Access Compliance Report

Public Rights-of-Way

(Pedestrian Signals)

Intersection ID: N/A	Main Street:	Cross Street: N/A	Location: N/A
ADA ID: 2CC62B9CE759	Signal Type: One Push Button-APS	Overall Compliance: No	Severity Score: BTN 1: N/A BTN 2: N/A No BTN: N/A
Codes/Mitigation Info/Possible Solution		Field Measurements/Component Compliance

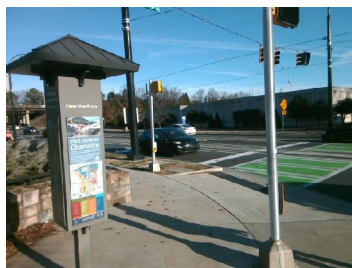
PROW/ADA: TMUTCD 4e.08, R404.2, R404.3, R406.2, R209.1, MUTCD 4e.10

Yes	B 1 Clear Xing Direction?	ClearlyMarked	N/A	B 2 Clear Xing Direction?	N/A
	B 1 Crossing Direction	To SE		B 2 Crossing Direction	N/A
Yes	B 1 DistanceTo XWalk (in)	0.0	N/A	B 2 DistanceTo XWalk (in)	N/A
No	B 1 DistanceTo Curb (in)	103.0	N/A	B 2 DistanceTo Curb (in)	N/A
Yes	B 1 Diameter (in)	2.0	N/A	B 2 Diameter (in)	N/A

Possible Solutions: Replace Signal Push Button With APS Button on New Post. Remove & Relocate Sign.
